<b>ADDENDUM NO. :</b>	<b>Four (4)</b>
<b>BID DUE TIME AND DATE:</b>	2:00 p.m., April 30, 2019 <b>(No Change)</b>
<b>BIDDER QUESTIONS BY:</b>	11:59 a.m., April 23, 2019
<b>LAST ADDENDUM ISSUED:</b>	11:59 p.m., April 25, 2019

**THE PURPOSE FOR THIS ADDENDUM IS:**

- **To provide a response to questions raised by Plan Holders;**
- **To modify/clarify specifications and drawings.**

A502

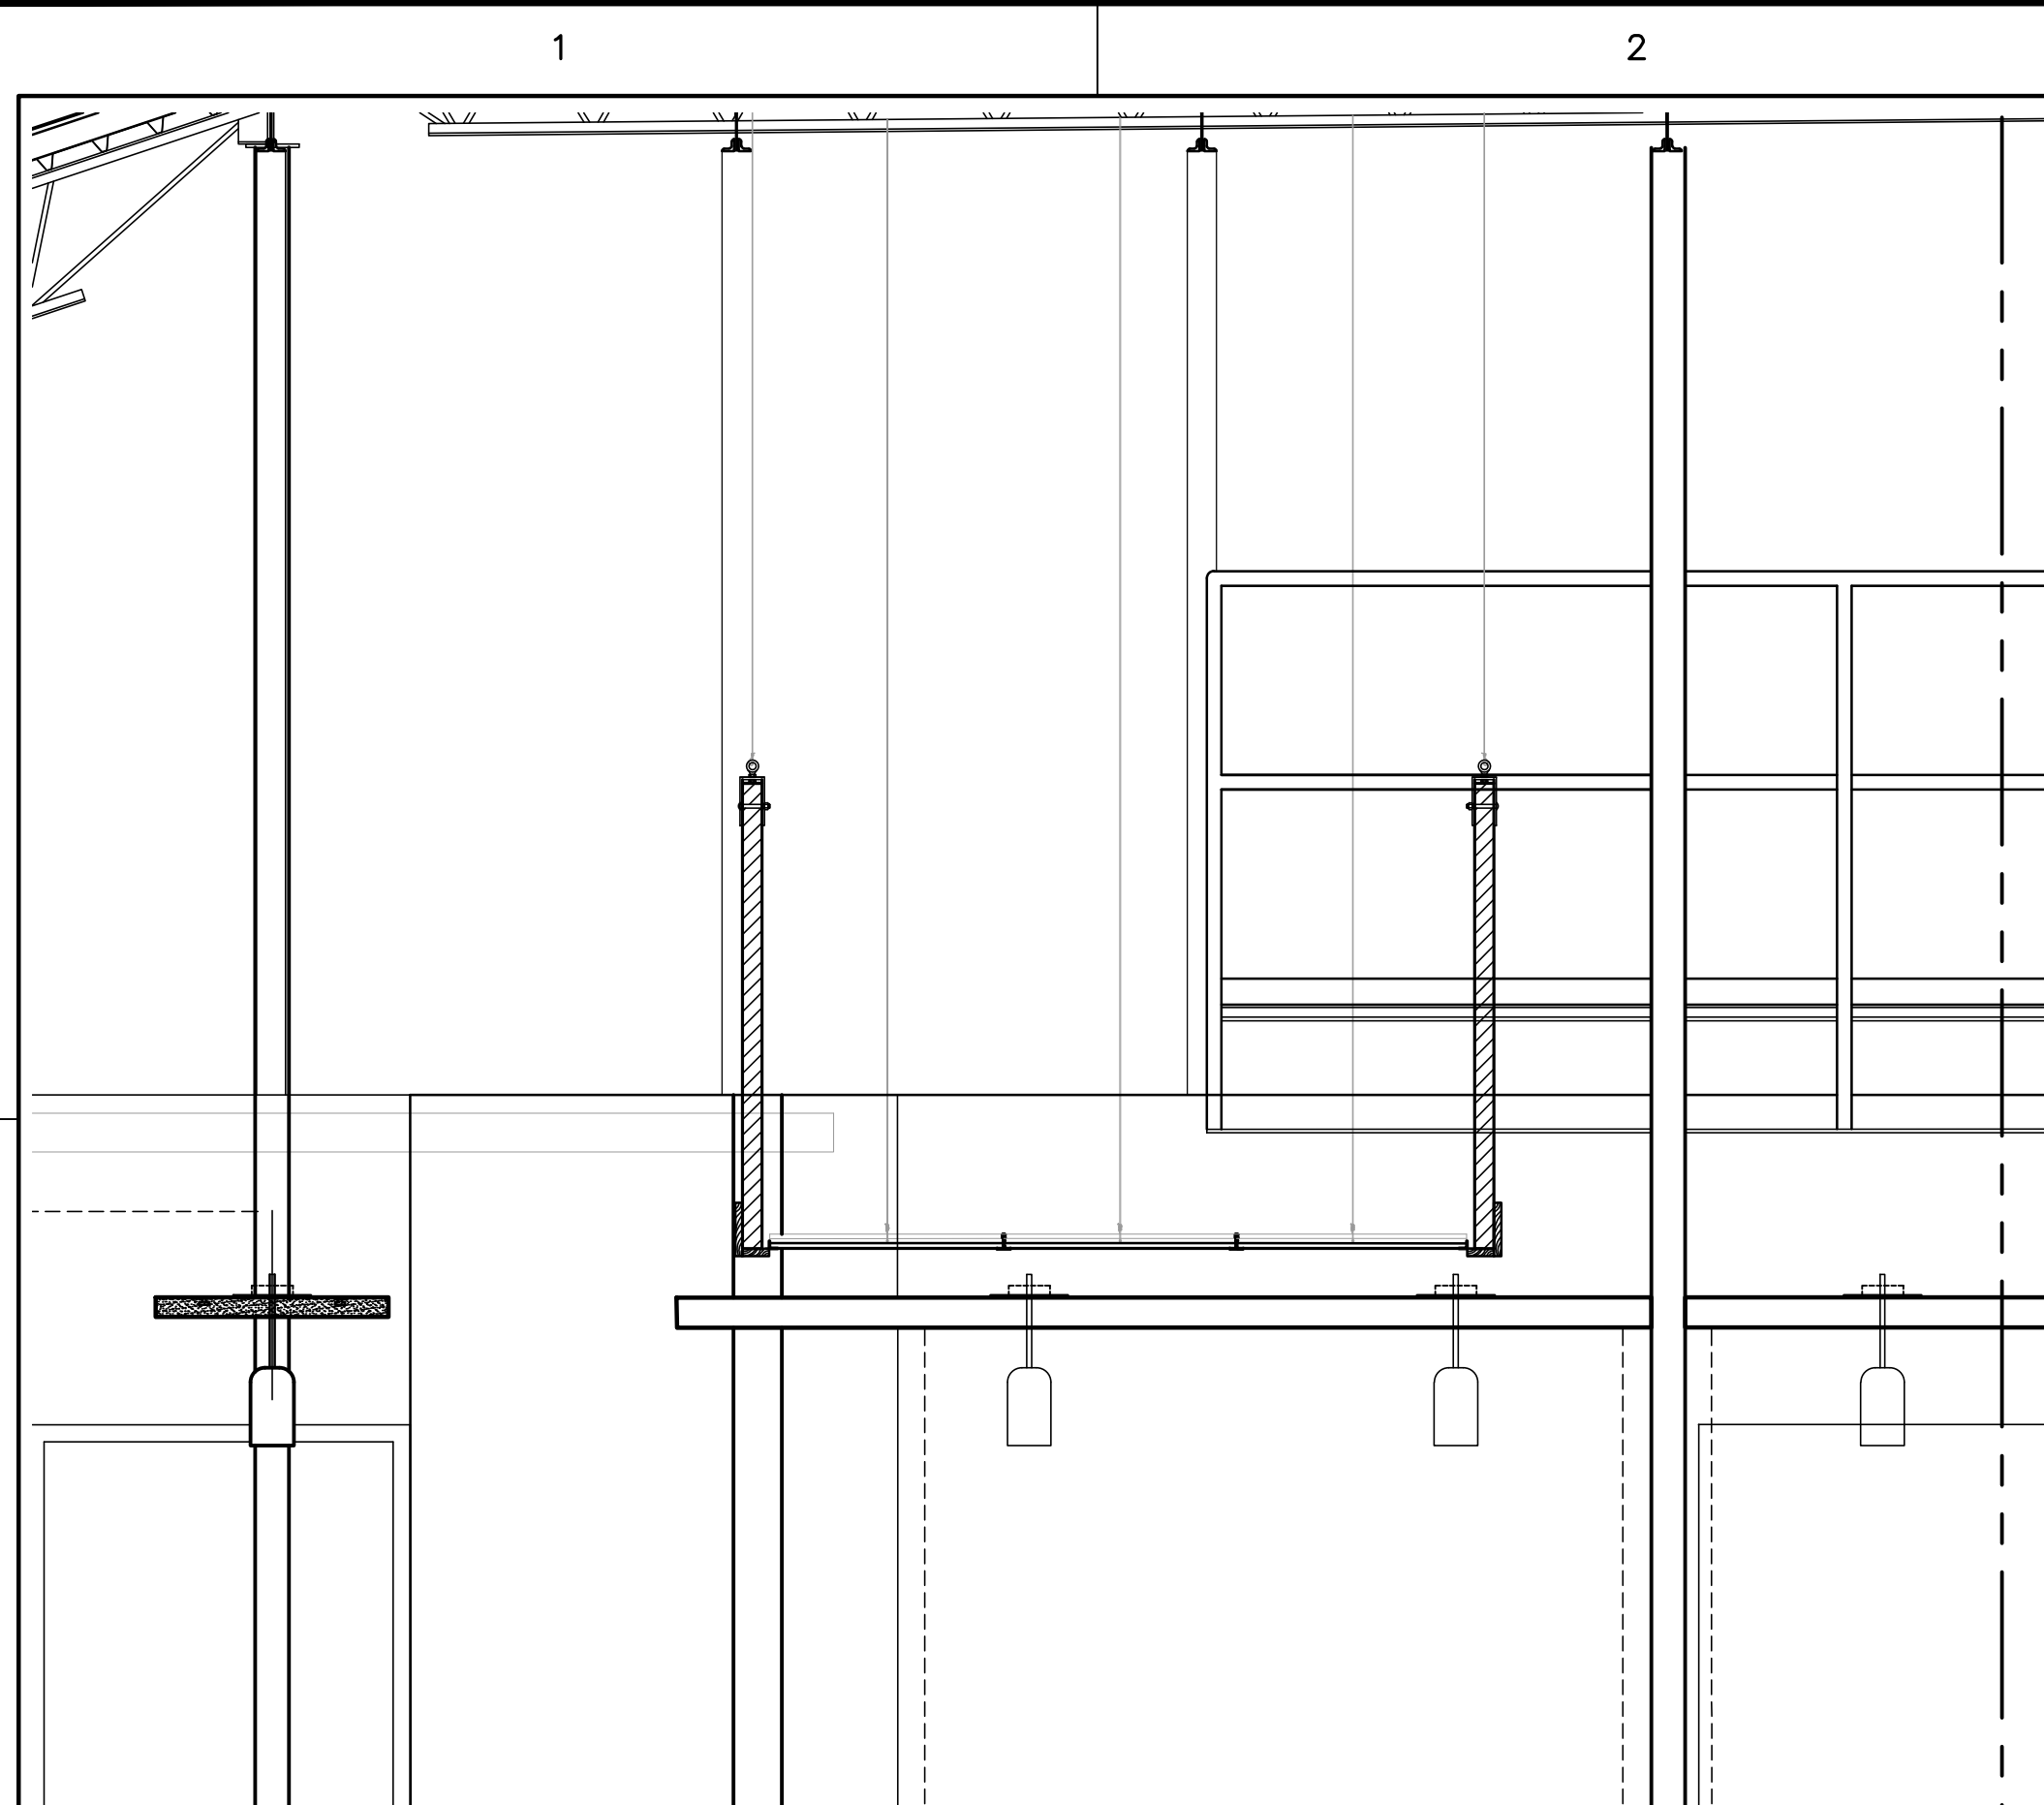
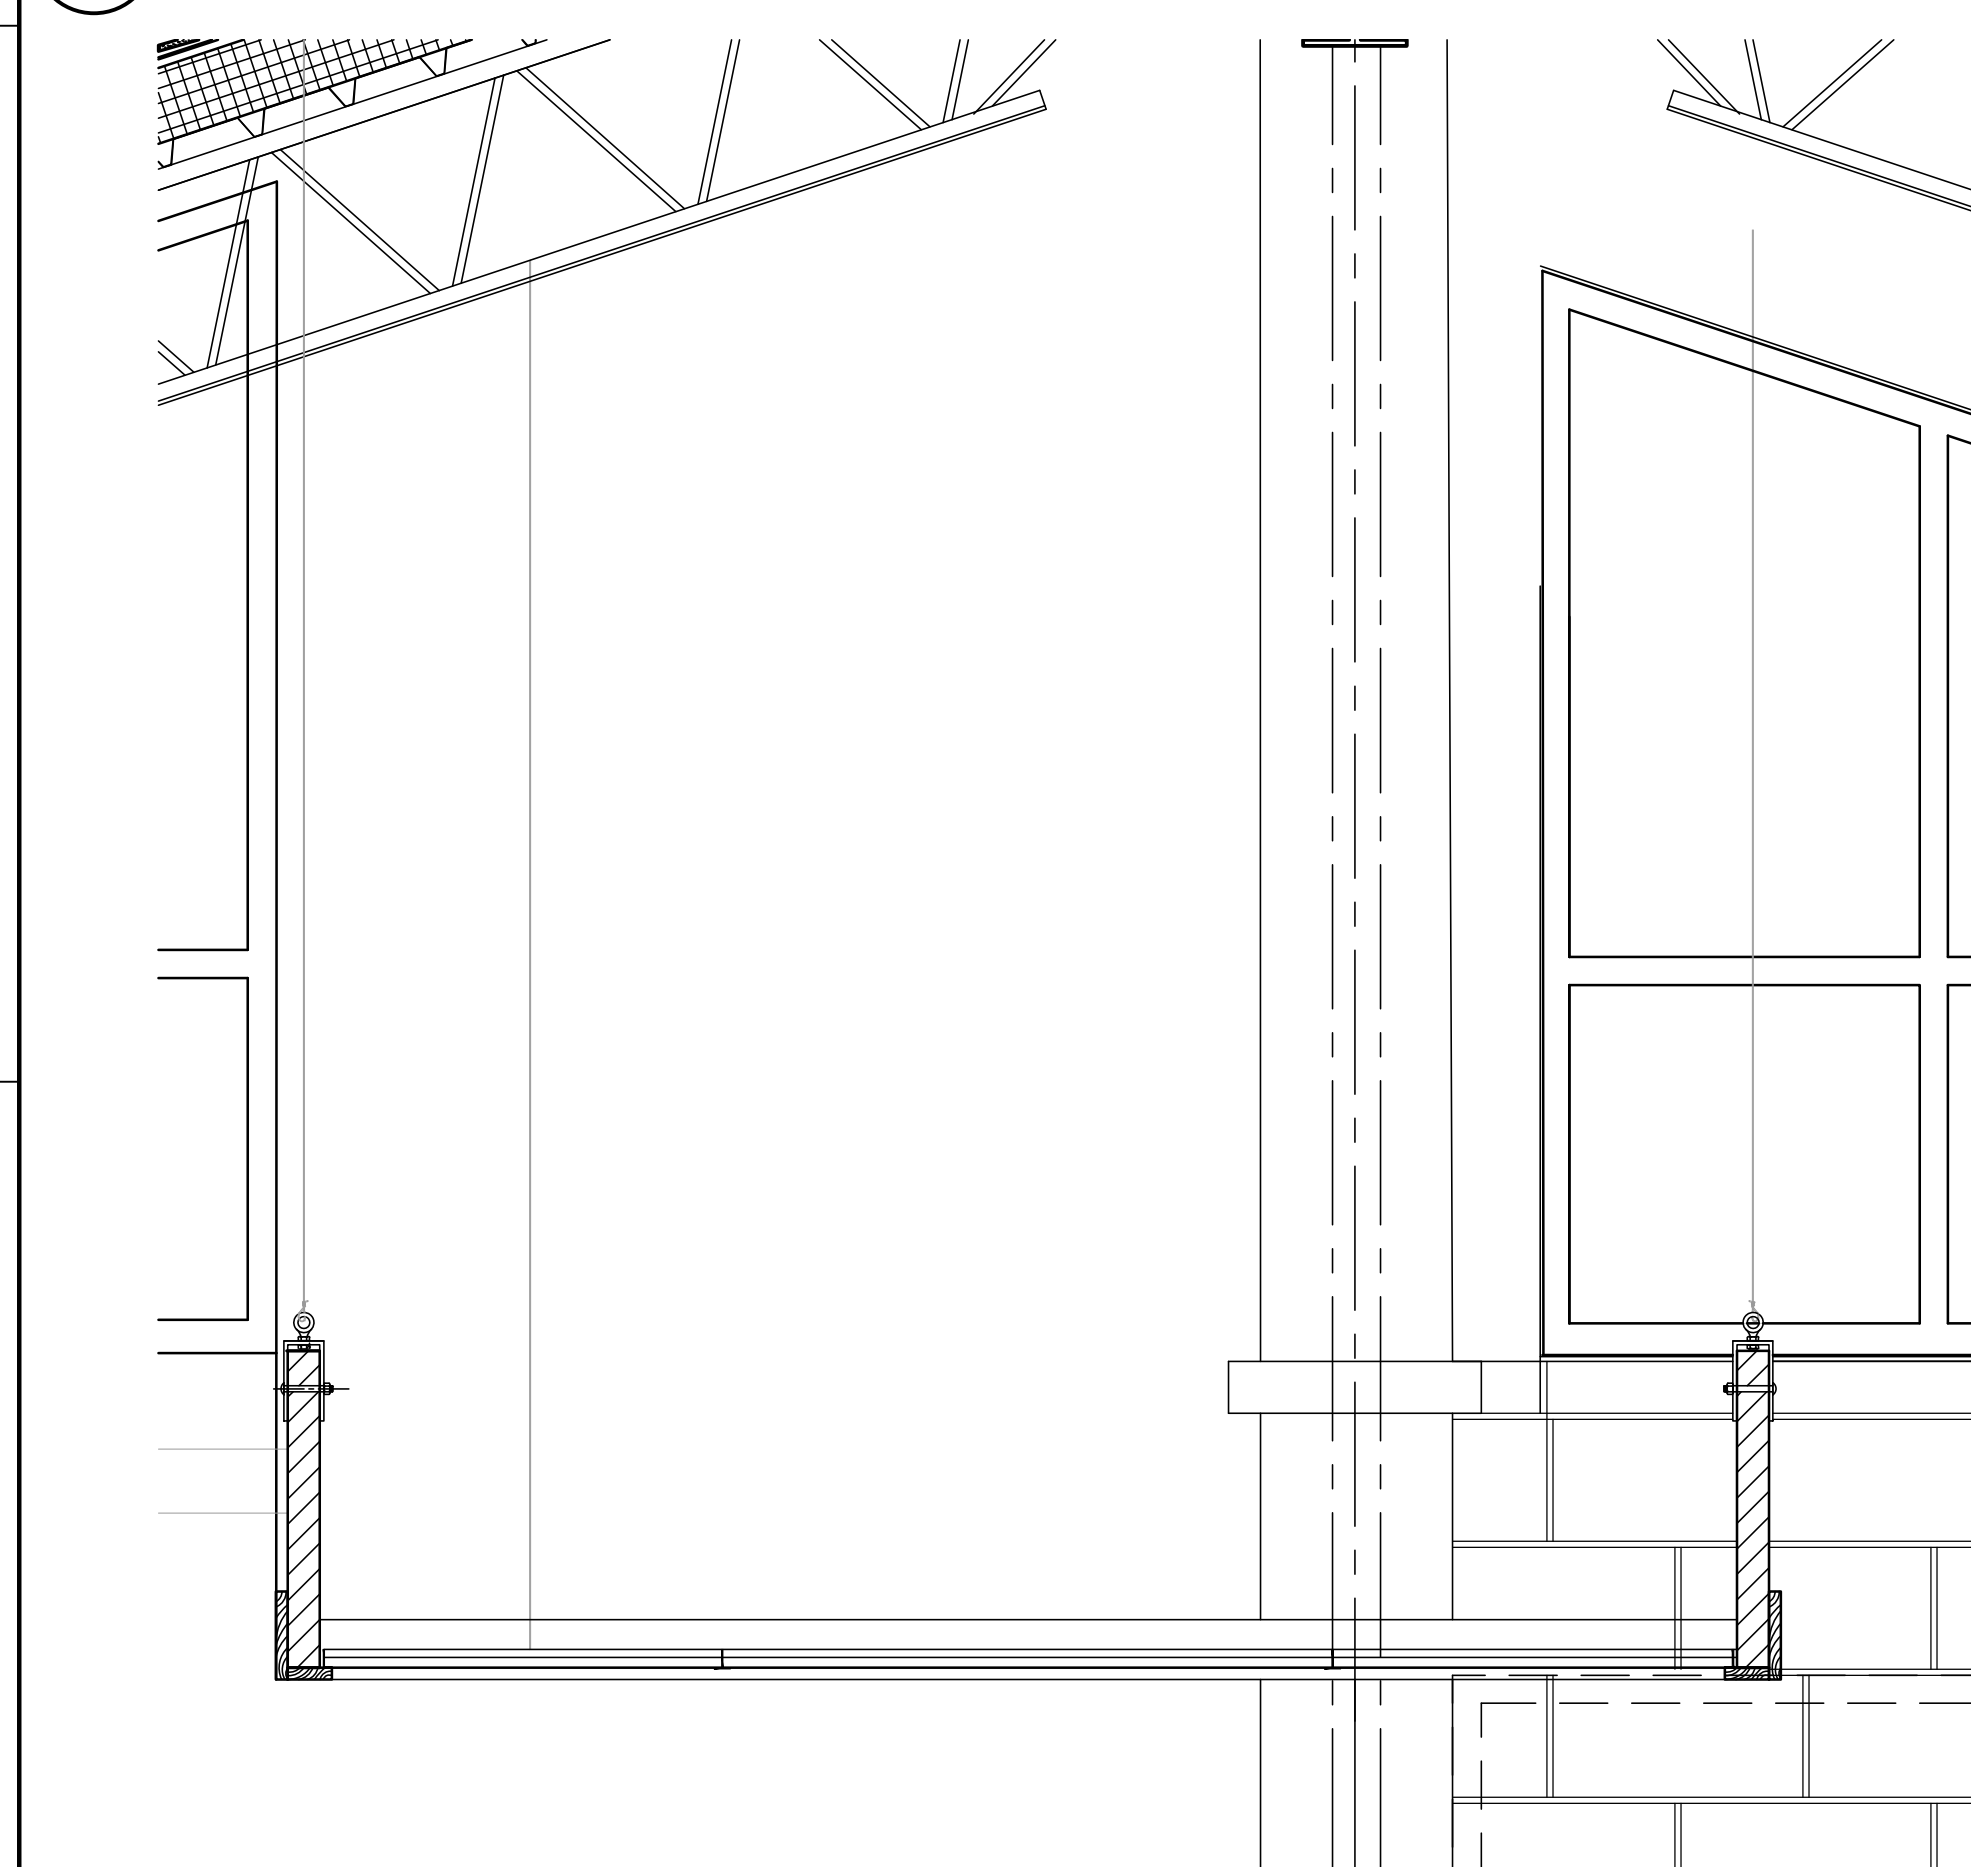
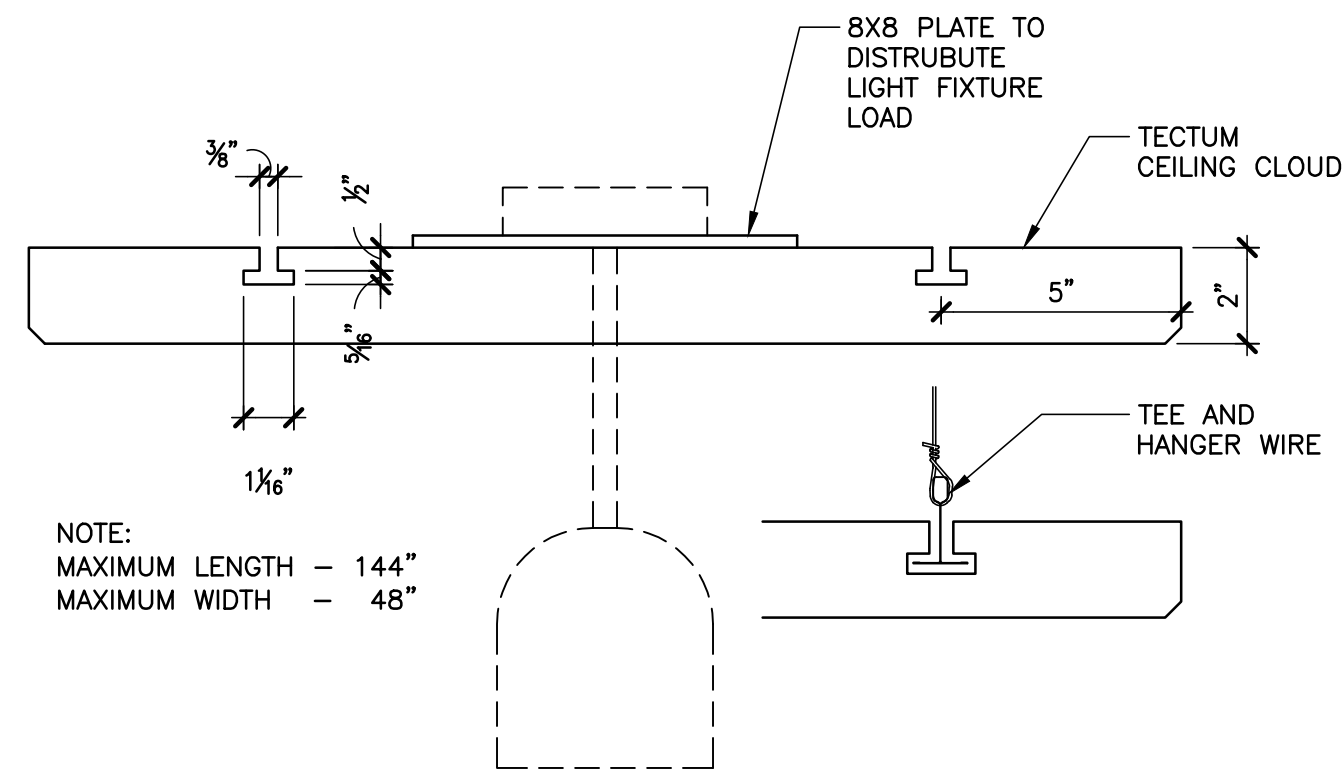
- Clarification on the wall types (section on acoustical separation, 2 hr, and detail at top of 10' wall) and ceiling cloud detail(s) and finish details such intent of columns for exposed electrical on CMU
- HVAC details such as air handler coil connection (what's needed re isolation valves, strainers, etc.)
- Extent of chilled water line treatment
- Specs/detail on OA louver to be installed within storefront (shown on HVAC, visible on Section A301, not A202 or A602)
- Redundancy on, and revisions to a few Hardware items; see hardware Spec sections attached.
- Sections clarified to indicate sill pan, as well as location of drainage barrier; all sections at stucco clarified to show weep at base of drainage plane. Additionally, simplify cast sills.

- A301 Building Sections
- A302 Building Sections
- A303 Ext Wall Sections & Details
- A304 Ext Wall Sections & Details
- A306 Ext Wall Sections & Details
- A502 Ceiling Details
- A601 Finish Schedule w/ Details
- P101, Updated plan to show missing fixtures and missing sanitary and vent piping
- P102, Updated plan to show missing fixtures, missing domestic water piping and missing gas piping
- P101, Updated plan to show missing fixtures and missing sanitary and vent piping
- P201, Updated plan to show missing fixtures and missing sanitary and vent piping
- P202, Updated plan to show missing fixtures, domestic water piping and missing gas piping
- M401, Added detail for chilled water connections to AHU
